SUBJECT: ADDENDUM # 4

PROJECT TITLE: ENERGY UPGRADES
MILFORD COURTHOUSE

PROJECT NO.: **BI-2B-315**

BID OPENING	**1:00 P.M.**	**MARCH 31, 2010**
ADDENDUM NUMBER 4	**DATE OF ADDENDUM**	**MARCH, 25, 2010**

1 RTU-1 PART PLAN

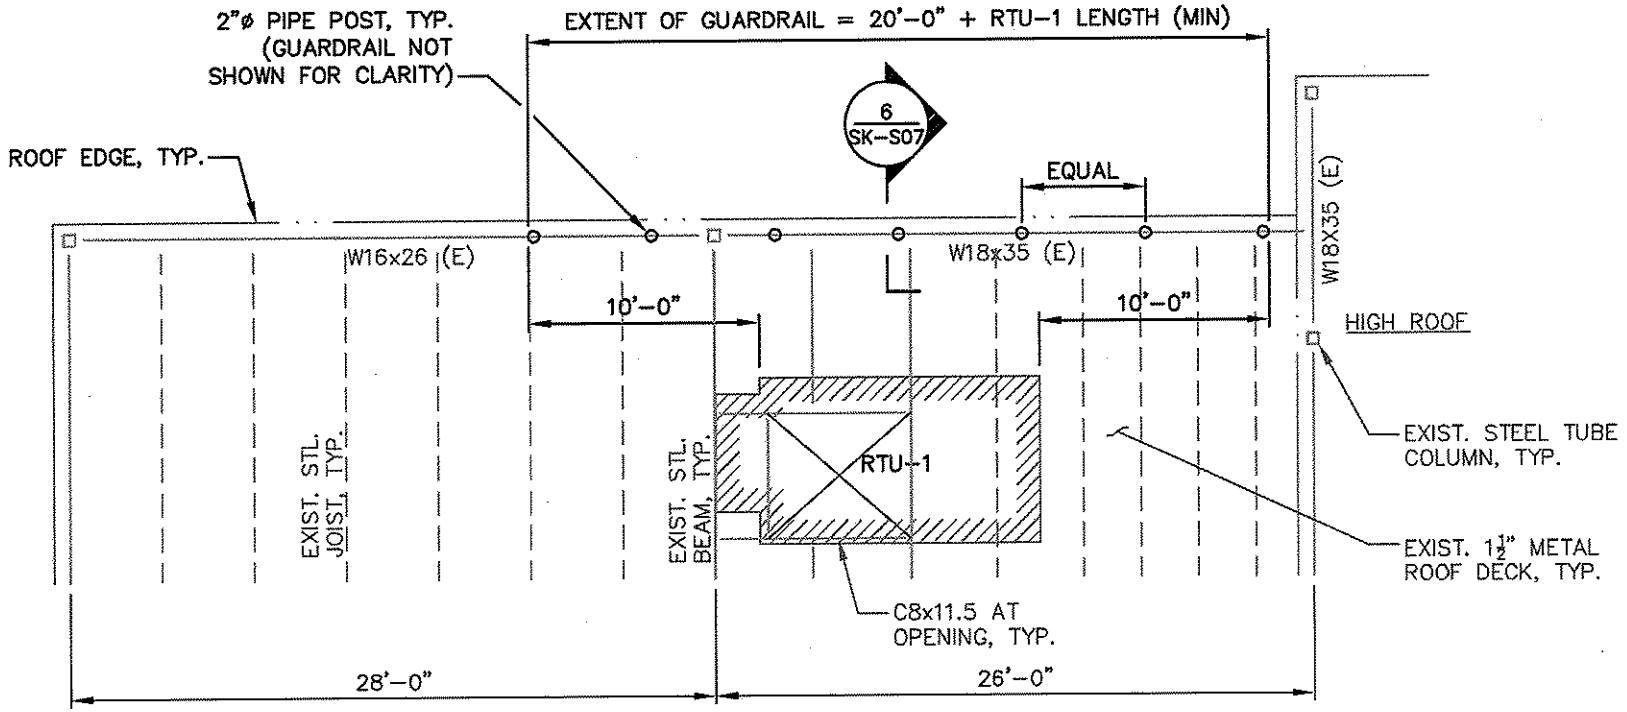
Add scope of work to drawing M-1.3 indicated by attached sketches SK-S01 thru SK-S09.

1 CONDENSING UNIT DEMOLITION PLAN

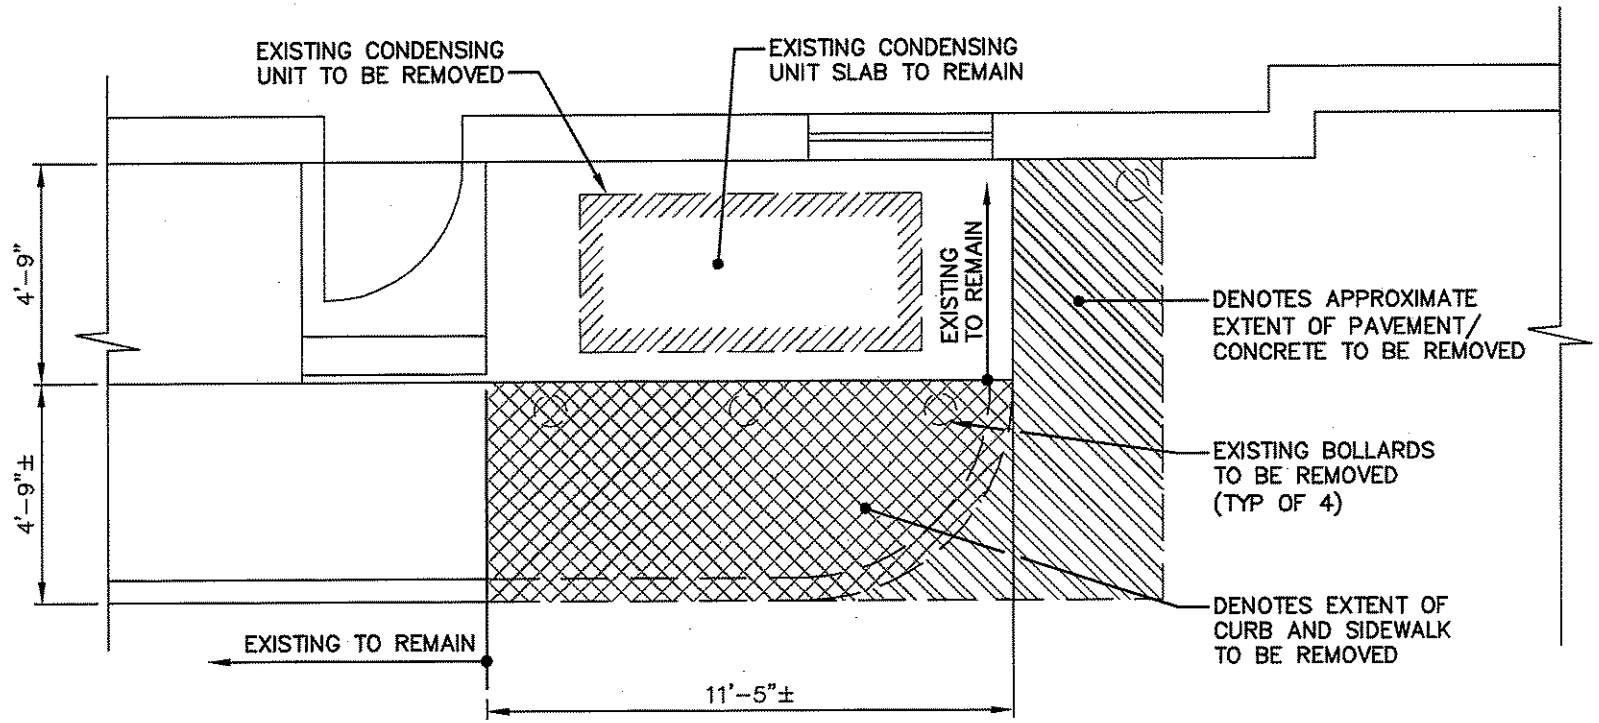
Add scope of work to drawing M-1.1 indicated by attached sketches SK-S10 thru SK-S15.

A1 MECHANICAL WORK PLAN – ROOF

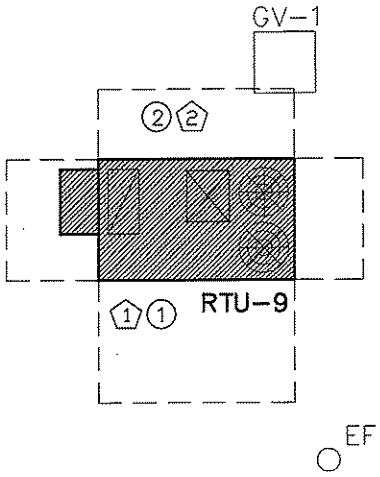
Add Alternate #1, RTU-9 replacement to scope of work on drawing M-1. Additional scope of work for Alternate #1 is indicated on attached sketch SKME-1.0. Break out price of work for RTU-9 replacement, and provide a separate cost for the Alternate #1.

1. REMOVE EXISTING ROOFTOP UNIT AND REPLACE WITH NEW RTU-9.
2. PROVIDE CURB ADAPTER. PERFORM FIELD MEASUREMENTS OF EXISTING CURBS PRIOR TO ORDERING ADAPTER CURBS. MODIFY AND EXTEND GAS PIPING AS REQUIRED FOR CONNECTION TO NEW RTU.
